Supplement #6

Date of Issue: March 18, 2025

Project: Mowat Middle School Cafeteria and Administration Addition

SHEET NO.:
 A1.1

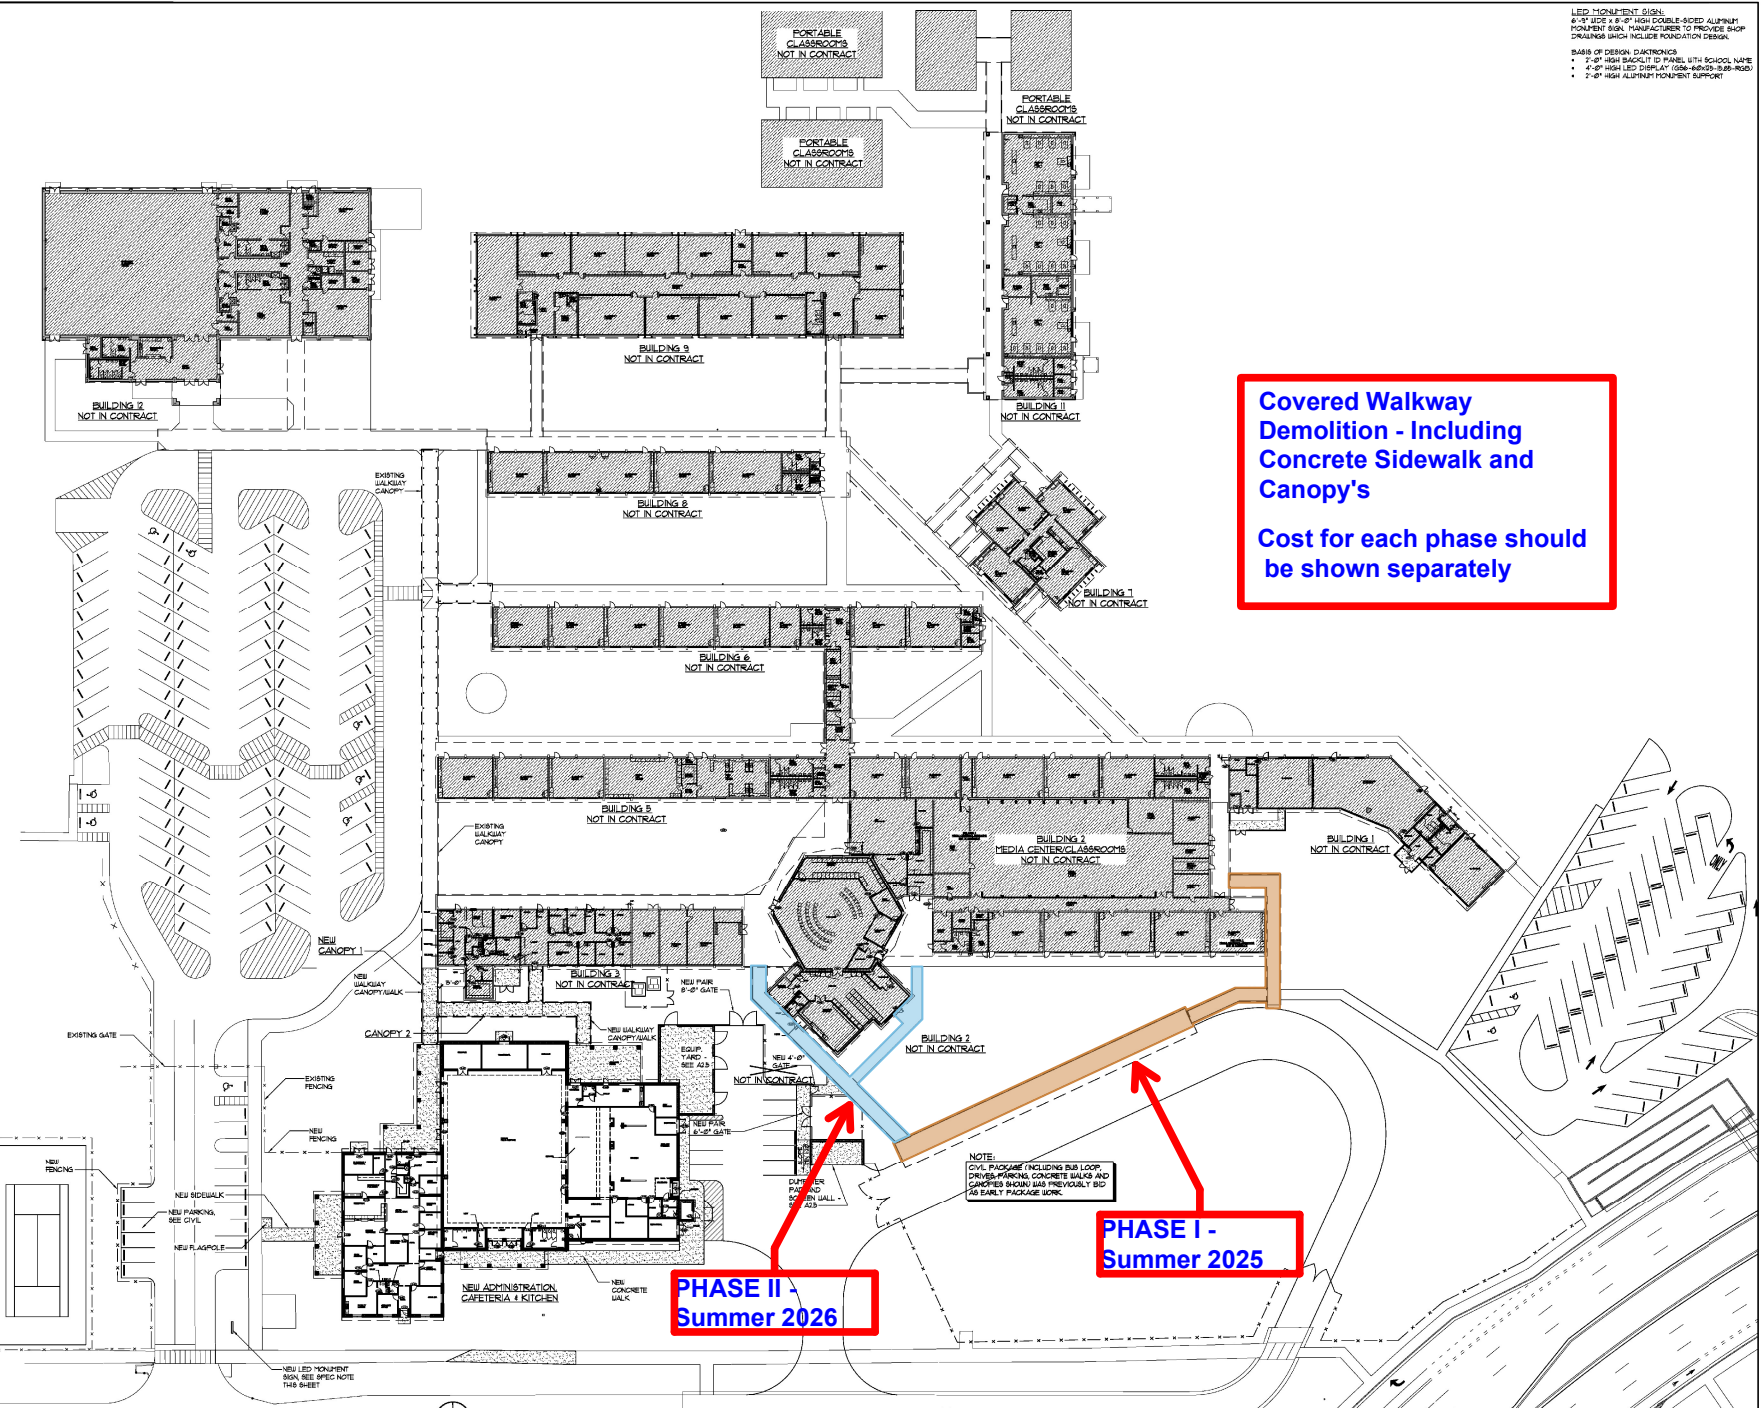
- Item 6.1 The bid date has been changed to **April 24, 2025 at 2:00 PM, CST**. Bids will be opened and publicly read aloud at Bay District School, Nelson Building, Board Room; 1311 Balboa Ave, Panama City, FL 32401. Late bids will not be accepted.
- Item 6.2 This supplement includes scope clarifications/illustrations for sitework and sidewalks to be included in this bid (See attachments).

**Covered Walkway
 Demolition - Including
 Concrete Sidewalk and
 Canopy's**

**Cost for each phase should
 be shown separately**

**PHASE II -
 Summer 2026**

**PHASE I -
 Summer 2025**
